GLOBAL ENERGY CONSULTANTS, LLC

DOCKET NUMBER
PROPOSED RULE **PR 12**
(68FR 49683)

Subject: Direct-to-Final Rule on Amendment No. 5 to CoC No. 1004

The above referenced proposed direct-to-final rule seeks to amend the regulations to revise the Standardized NUHOMS cask system to incorporate NUHOMS-32PT DSC under Amendment No. 5 to CoC Number 1004. We have examined the underlying technical material (the revised Technical Specification, the SER, and TN West's FSAR) and have determined that:

Figure 4.2-8
DSC Support Structure

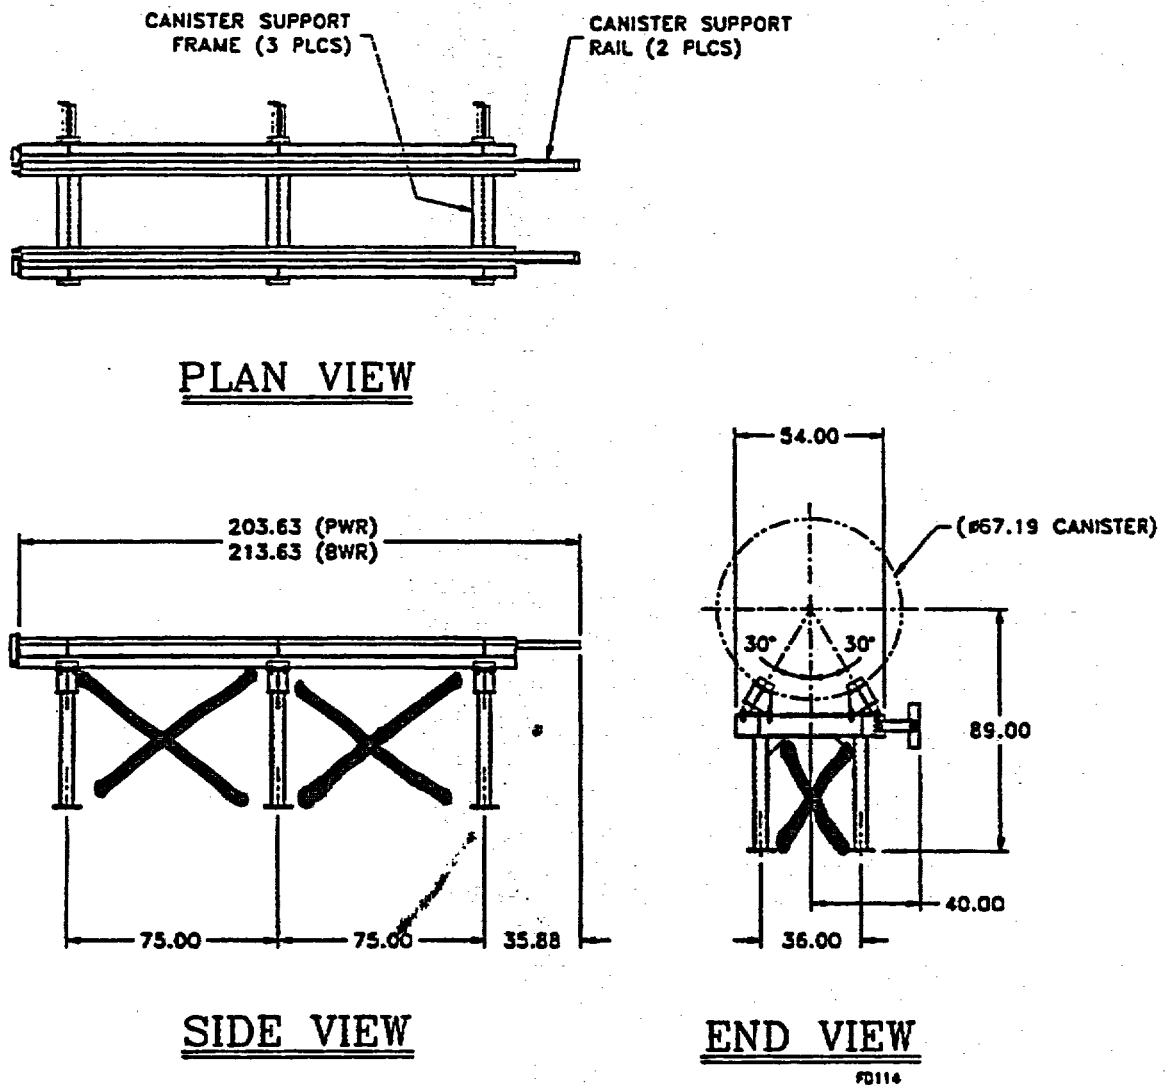
Further, it is noted that the 32PT DSC is the heaviest canister proposed for use thus far in the HSM. NUHOMS's FSAR asserts that the DSC support structure is braced, presumably to incorporate seismic resistance. A review of the sketches provided in the FSAR show no bracing.

In Appendix B, I have placed a marked copy of the pages from the FSAR [4], where I have marked (in felt pen) the missing braces.

Without the braces, the DSC support structure in the HSM is weak against axial or lateral overturning moments, especially the increased g-loads that will accompany the heavier 32PT DSC.

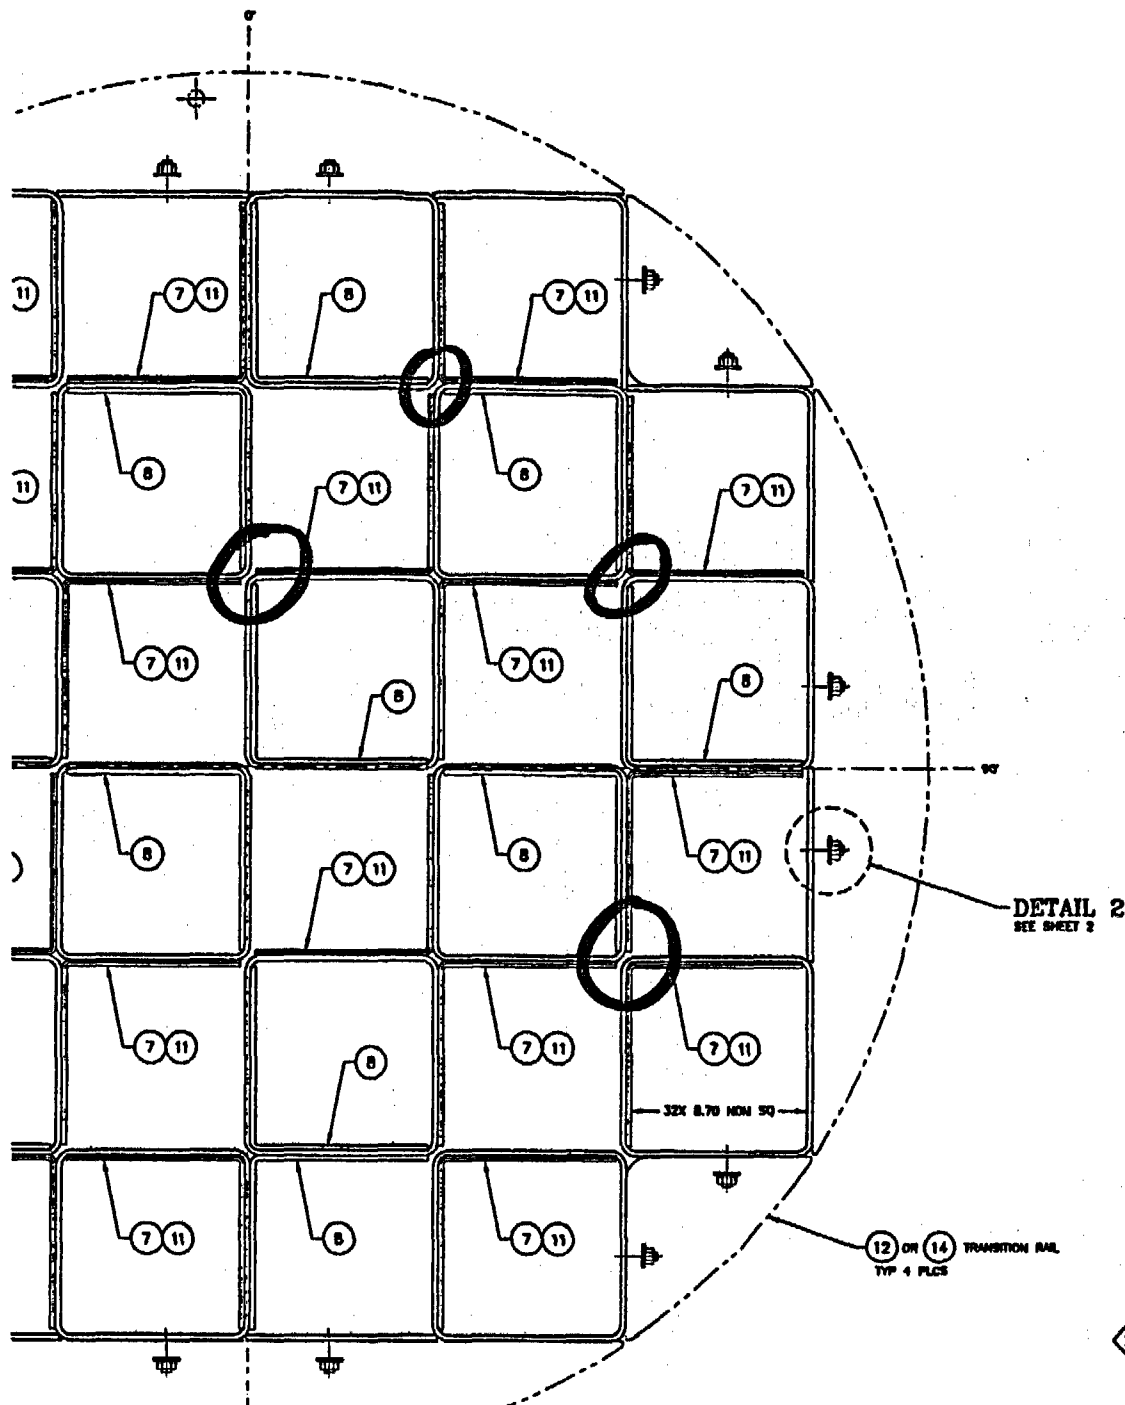
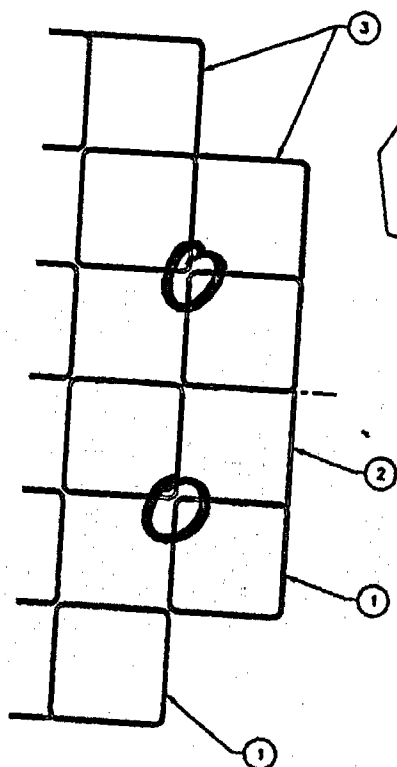
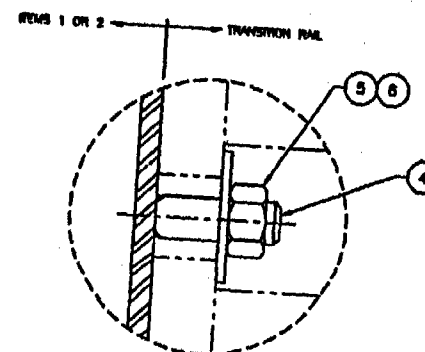
Of an even greater concern is the clear absence of critical structural welds in the fuel basket in DSC 32 PT. I have manually circled areas in the limited drawing details released to the public that show absence of welds in the fuel basket at critical load transfer locations under a horizontal drop condition (see Appendix B). TNW's stress analysis of the basket appears to have a serious error – perhaps an erroneous assumption in the finite element model. Critical stress analyses figures are deleted from the non-proprietary copy; therefore, I cannot provide further help.
